**BEFORE A HEARING PANEL
CONSTITUTED BY UPPER HUTT CITY
COUNCIL**

**PPC55
Gabites Block**

an application by **Maymorn Developments Ltd**
for a private change to the Upper Hutt District
Plan (Private Plan Change 55)

Brief of Evidence of: David Patrick Wilson

Figure 1 GD04 Figure 9 demonstrating cumulative effect of de-centralised detention facilities

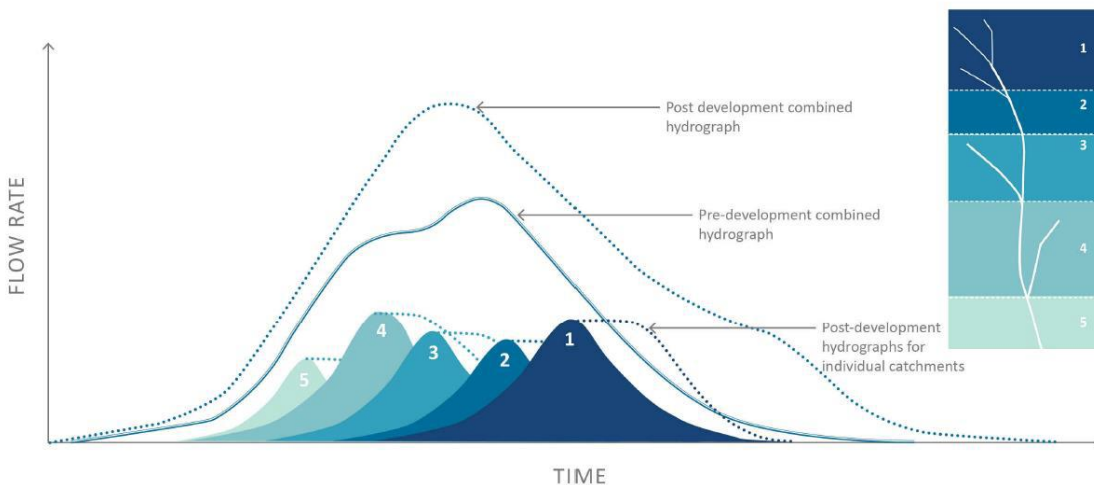
36. The attenuation requirements cannot be confirmed without modelling of the proposed system. This is because if separate attenuation facilities for multiple subcatchments each attenuate peak flows to 100% of pre-development peak flow, the increased volume discharged from each attenuated subcatchment will result in flows being high for longer. Downstream where flows from multiple subcatchments combine, the discharge hydrographs (flow varying over time) will accumulate and depending on the timing this may lead to a higher total peak flow from the whole catchment than pre-development. This is illustrated in the figure below, Figure 9 from Auckland Council's GD04.

Figure 3 Preferred ZMP for the Plateau Road and Maymorn zone

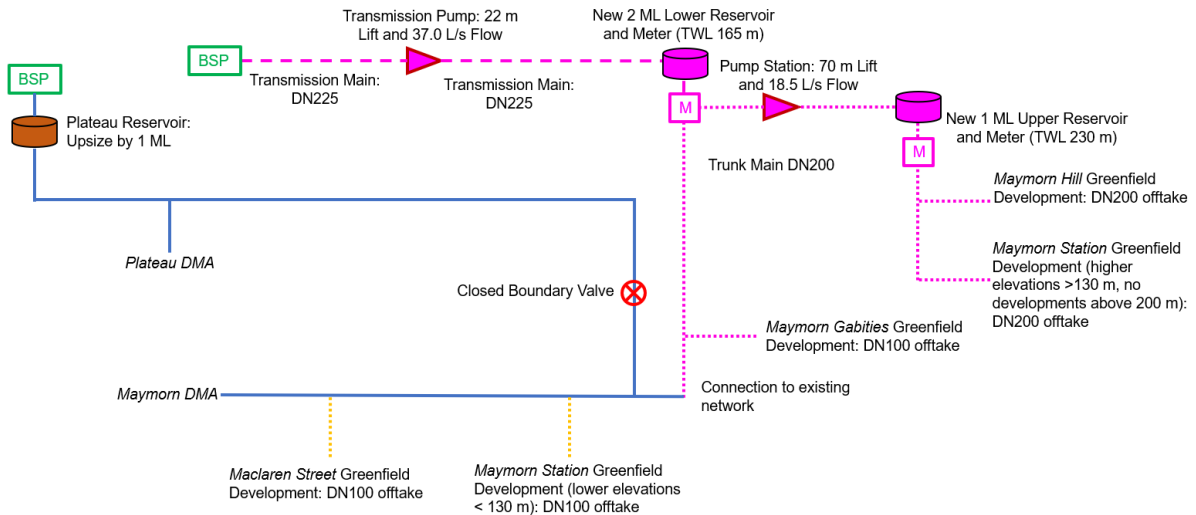
87. The preferred ZMP option for the Plateau Road and Maymorn zone is a two new reservoirs for the Maymorn DMA that a fed directly from the new pump station connected to the bulk water supply. As well as increased storage at the Plateau Road Reservoir, see Figure 3 below.

88. Funding for this ZMP is not included in UHCC's current long term plan, so there is no certainty when and if this ZMP will be implemented.
89. Therefore, the only option for water supply for the Site is on lot water supply. Wellington Water's Wellington Water's Regional Standard for Water Services Version 3.0 December 2021 (RSWSR) is silent regarding on site water supply requirements. Therefore the on site water storage will need to meet the requirements of UHCC Code of practice for Land Development 1998 (COP) and the SNZ PAS 4509:2008 New Zealand Fire Service Firefighting Water Supplies Code of Practice.
